Mack Trucks, Inc.
Greensboro, NC USA

Aftertreatment Diesel Particulate Filter (DPF)
Inlet Pipe

GU
Cummins ISL

PI0795, Aftertreatment Diesel Particulate Filter (DPF) Inlet Pipe

W2076382

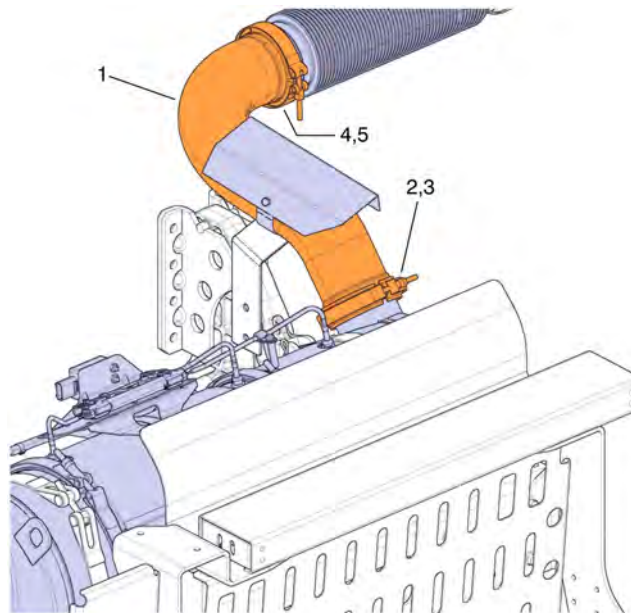
Certain Mack GU trucks with the Cummins ISL engine built from 8-25-2011 to 4-11-2012 may exhibit an exhaust leak at the Aftertreatment Diesel Particulate Filter (DPF) inlet pipe. The DPF inlet pipe flange has been modified to improve the sealing function of the DPF inlet pipe. Trucks built between these dates should replace the DPF inlet pipe (21534291) with new inlet pipe (21921104). New gaskets are installed on both ends of the new DPF inlet pipe. Additionally, a new v-band clamp (21601828) is required to complete the installation.

DPF Inlet Pipe Parts			
Item #	QTY	Part Number	Description
1	1	21921104	Exhaust Pipe, DPF Inlet
2	1	21601828	V-Band Clamp, DPF Inlet Pipe to DPF
3	1	21601830	Gasket (DPF Inlet)
4	1	21095721	Gasket (Flex Pipe)
5	1	N/A	V-Band Clamp to Flex Pipe, Existing
